ADDENDUM

PROJECT: University of South Dakota
Arts & Sciences
Classroom 22
Vermillion, South Dakota

AD-3

DATE ISSUED: Monday, January 19, 2015

2 LOUVER DETAIL (PARTIAL)
Scale: 3/4" = 1'-0"

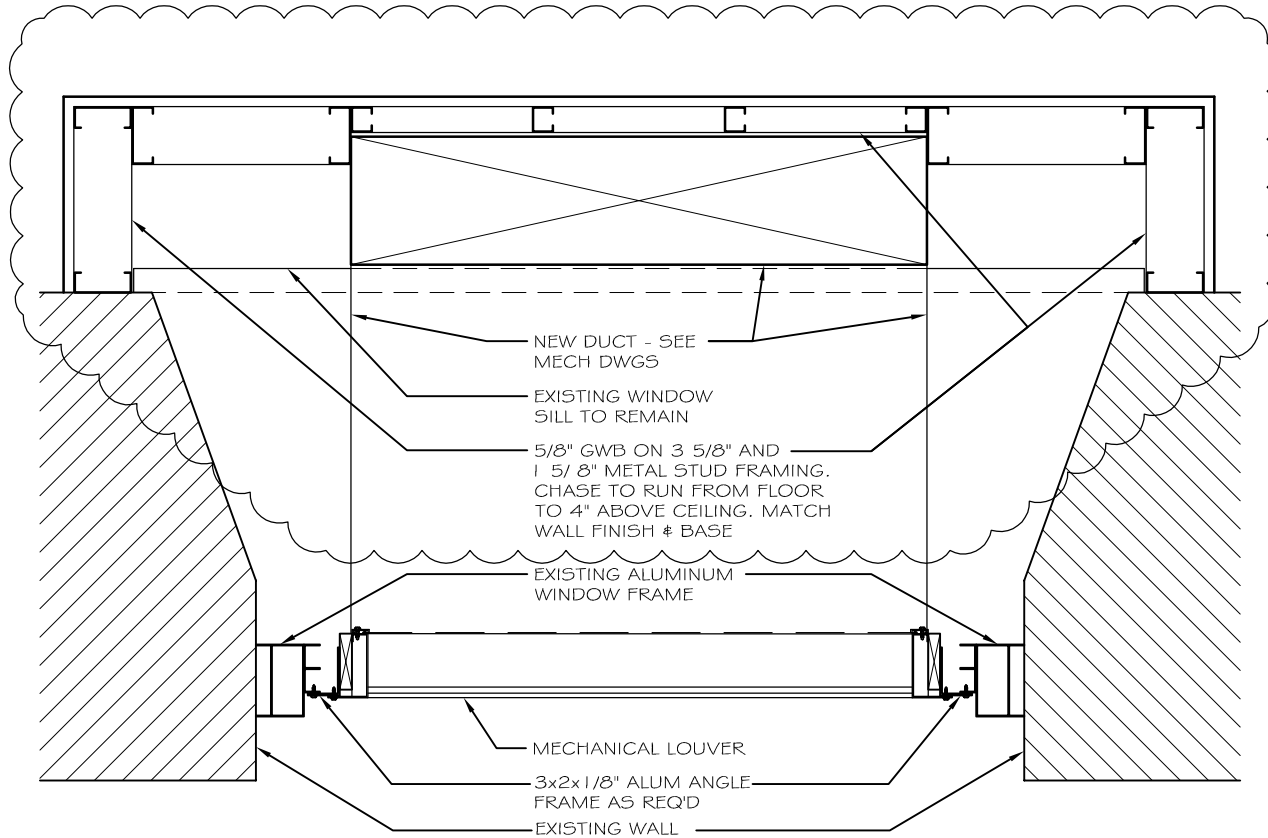
In reference to Sheet A-101, provide gypsum wall board and metal stud chase to enclose louver. Refer to drawing A-101.1.

Basement Mechanical Plan

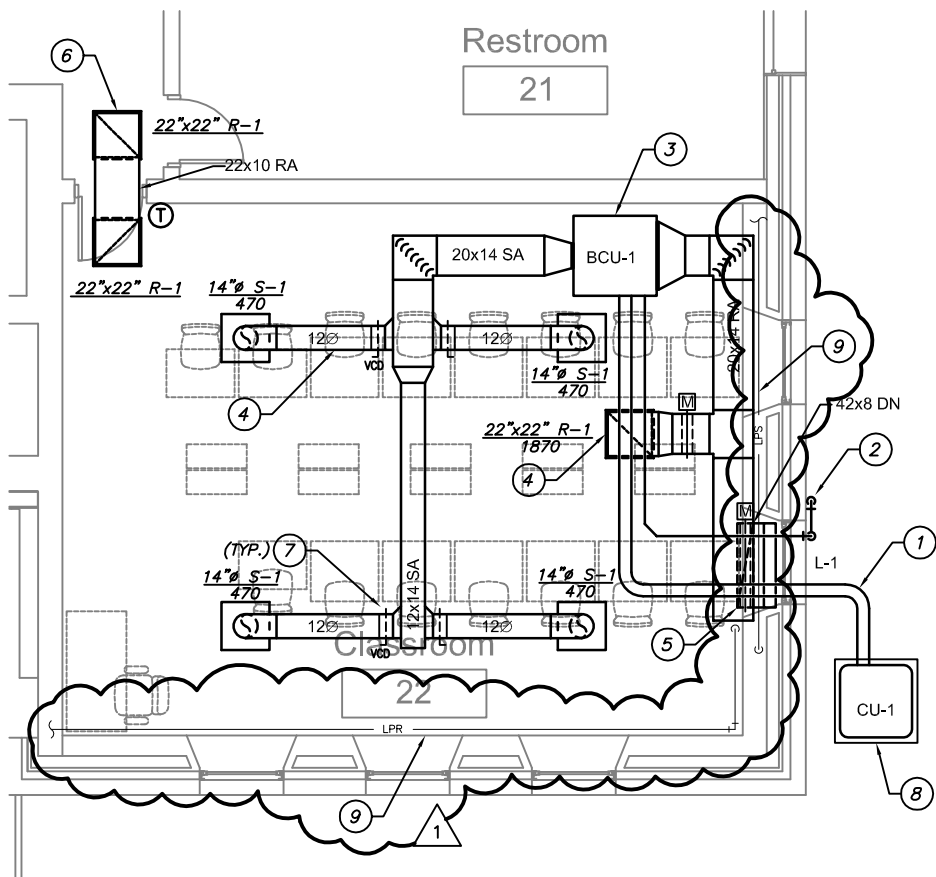
In reference to Sheet M-101, insulate the existing steam and condensate piping as shown on attached drawing M-101.1.

⑨ REPLACE EXISTING INSULATION WITH NEW SAME SIZE TYPE II MINERAL FIBER PIPE INSULATION WITH ASJ ON EXISTING STEAM AND CONDENSATE PIPE. CONTRACTOR SHALL FIELD VERIFY PIPE SIZE AND INSULATION THICKNESS.
